**BLOOMINGTON PLAN COMMISSION
STAFF REPORT
Location: 121 E. Kirkwood Ave.**

**CASE #: SP-34-17
DATE: March 5, 2018**

Re: Project Review Summary for 121 East Kirkwood Avenue
Bloomington City Architect - 2017-040.000

BUILDING HEIGHT DIAGRAM

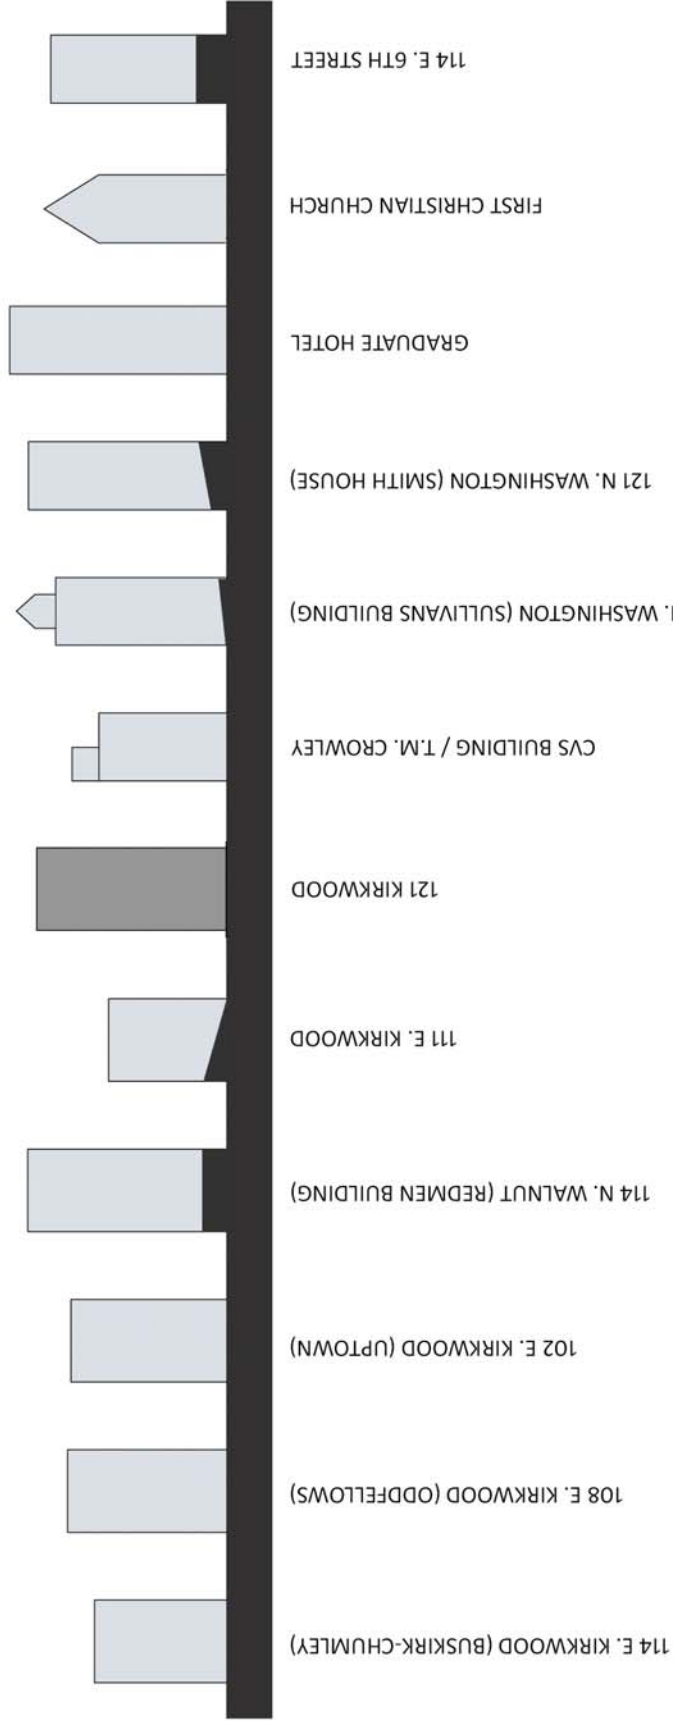
Height: The maximum height in the CSO was 40 feet at the time the petition was filed. This petition is not subject to the new maximum height of 30 feet. The UDO defines building height as “the vertical dimension from the lowest point of the building, structure, or wall exposed above the ground surface to the highest point of the roof, parapet wall, or uppermost part. Chimneys, vents, mechanical equipment or utility service structures shall not be included in the measurement of vertical dimension.” The building measures 56 feet tall per the UDO definition. The tallest part of the building is from the south east corner of the lot along Kirkwood to the top of the limestone parapet wall. From the southeast corner of the lot to the top of the roof, the building is approximately 50’ tall. This petition exceeds the maximum permitted height of the CSO by 16 feet. The petitioner has

attempted to reduce the perceived height of the building by stepping back the fifth floor by about 10 feet.

The proposal is about 1 1/3 stories (16 feet) taller than the historic Book Corner building to the west. The three story facade is comparable in height to the Oddfellows (Farm) building and the Uptown on the south side of Kirkwood and the CVS building on the same zoning lot to the east. The proposed 4th floor is stepped back at least 10 feet in all areas except the stair tower which reduces the perceived height of the building along the street. The building is comparable in height to the Redman building on the square and the Sullivan's building on Washington Street.

Ⓜ NORTH ELEVATION
SCALE: 1/8" = 1'-0"

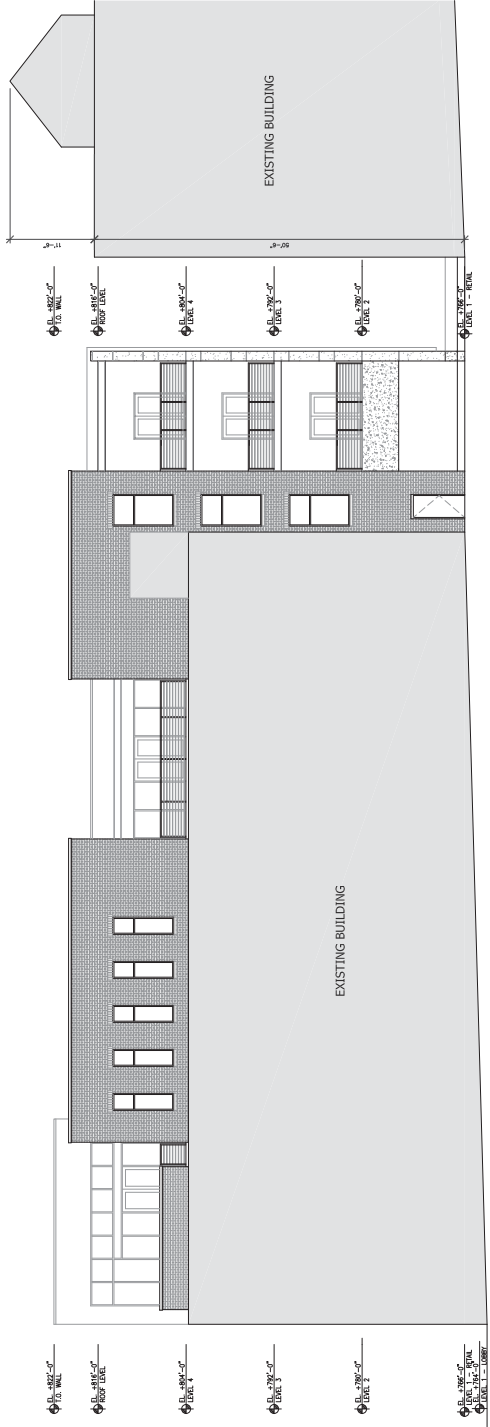
10. The brick façade element on the north elevation has been modified by recessing a portion of the façade. This helps in a minor way to bridge the two sides of the façade.
